TOWN OF MELBOURNE BEACH

**PLANNING & ZONING BOARD
MEETING**

Section: New Business
Meeting Date: March 10, 2026
From: Building Department
RE: Site Plan Approval for 307 Third Ave. – New Home

Site Plan Review

DEMO PLAN 1" = 20'

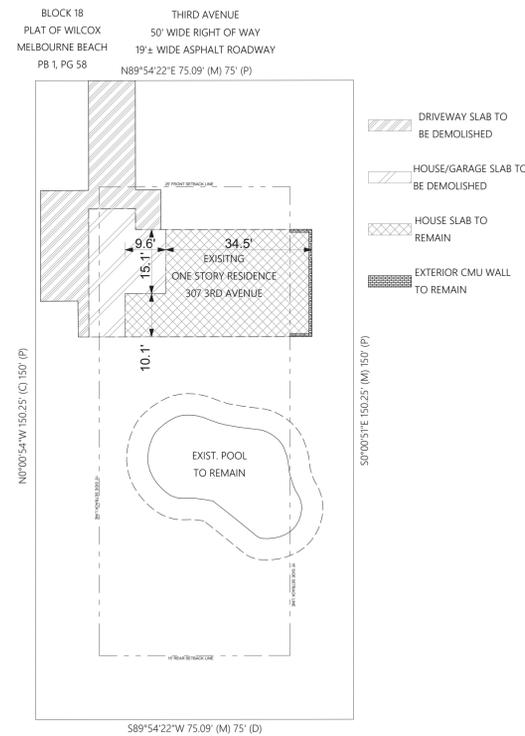
Also, the application says it is a renovation but there is nothing in the plans to indicate what is existing and what is proposed except for the “demo” plan on sheet C-1 that appears to show that most of the structure is being demolished. If so, since the code defines structures as “a combination of materials that form a construction for use, occupancy, or ornamentation whether installed on, above, or below the surface of land or water. Included are buildings, roads, walkways, paths, swimming pools, tennis courts, pipelines, underground transmission lines, sheds and the like” it is possible that the following code language would apply because the structure is nonconforming with regard to the side interior setback:

If so, the entire structure will need to comply with the side setback. Also, they show a detached garage but show no driveway to access the garage.

LOT LAYOUT PLAN 1" = 10'

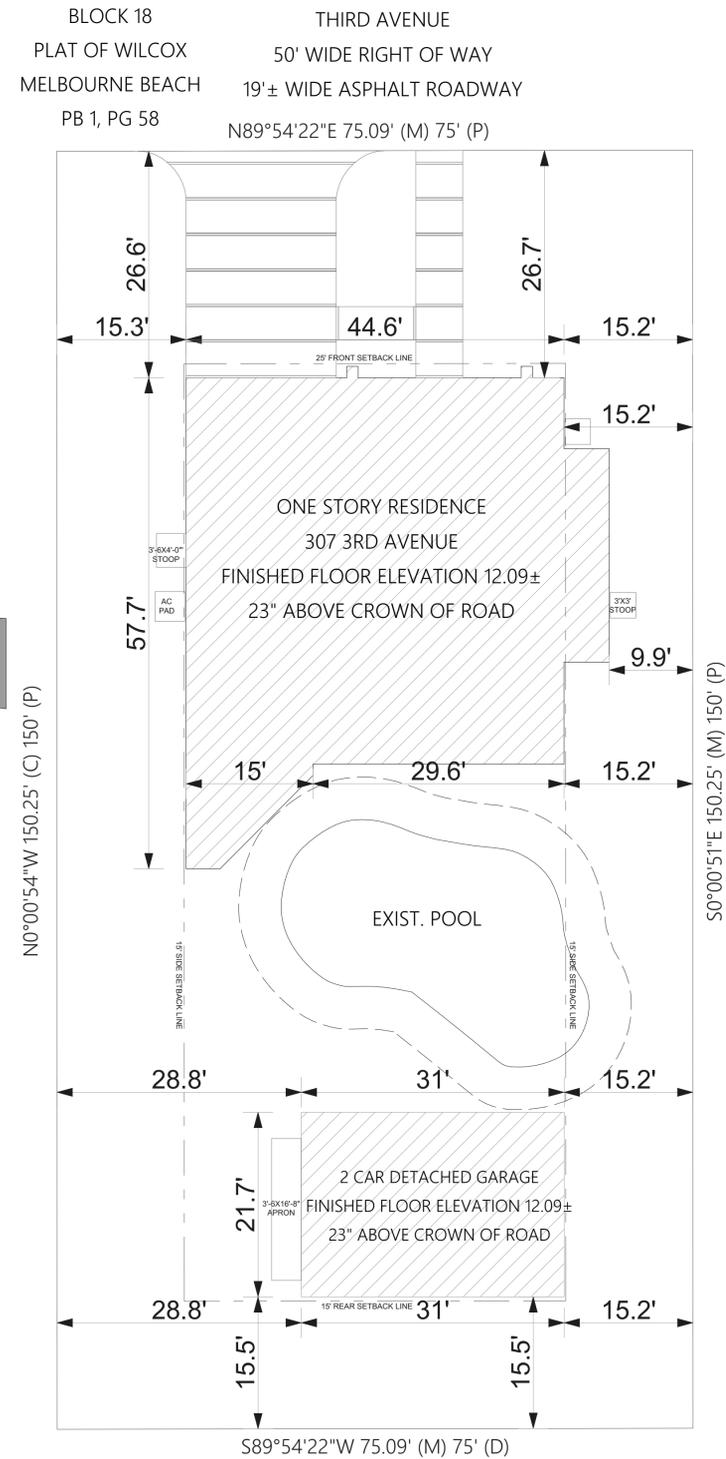
In addition, the proposed plan includes a detached 2-car garage on the rear of the site and access is provided via a rock driveway connecting the driveway access to Third Avenue between the west side of the home and the property line to the garage. Code 7A-50(a) specifies that if the gross floor area of a principal structure is expanded or enlarged then off-street parking serving the site shall be increased to the number of additional parking spaces required. In this case, there is a 1-car garage proposed in the principal structure, however the Town Code requires “enclosed parking space must be provided for at least two vehicles”, and as such the addition of the detached garage ensures compliance with this requirement.

Note that the architectural site plan does not include the rock driveway and includes slightly different configuration of walkways, so for review of pervious/impervious, the civil engineering site plan was utilized. All other items including setbacks, building locations and sizes, etc., appear to be the same, and the architectural site plan should be revised to be consistent with the civil plan at the time of permitting.

Note that, per the civil engineer, the rock driveway is designed to be pervious and is included in the "pervious" calculations on the next page and on the civil engineering plans.

GRADING AND DRAINAGE PLAN
1"=20'

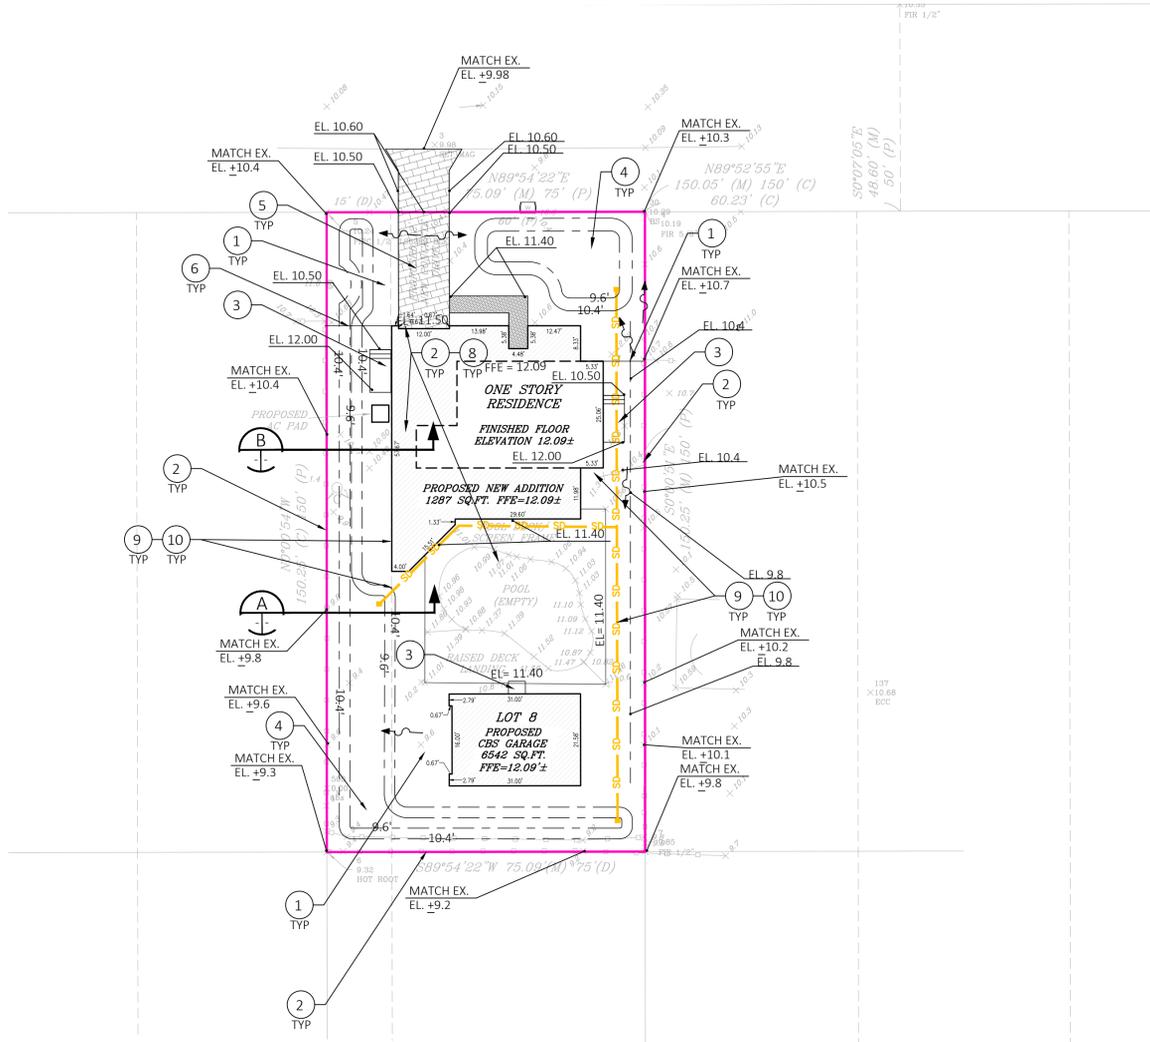
On the driveway issue, there is a gravel driveway on the grading and drainage plan. This was not put on the engineering plans because they say a driveway isn't a requirement per Melbourne

Beach Town Ordinance (I am trying to verify this). **Section 7A-50 requires “enclosed parking space must be provided for at least two vehicles”, and although the code does not specify design standards for a driveway one must be provided in order to ensure accessibility of the vehicles to the two required parking spaces. On the grading and drainage plan that was attached to your email there is a drainage swale on the west side of the property, and I see no gravel driveway, so as designed the detached garage is not accessible by a vehicle and cannot be approved.**
